Technical Service Bulletin

TSB # T2006-01

Product: Gateway AI

Vehicle: 2005-2006 Ford E-Series

Gateway Module located on left side of driver knee bolster bracket

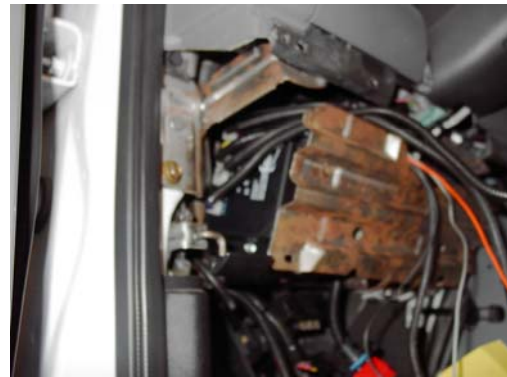
Issue: Module repeatedly resets due to excessive ambient temperature of 150 °F or higher. The module will not function and all LED's on the display panels flash repeatedly.

Action: Determine if the ambient temperature in the area of the module is at or above 150 °F. If so, determine the external heat source. This will typically be caused by engine heat if the module is mounted near the engine cover or hot air being supplied by the heater ducts. Relocate the module in an area away from the external heat sources. See photos below for suggested mounting area.

Gateway Module installed on left side of knee bolster bracket in vehicle
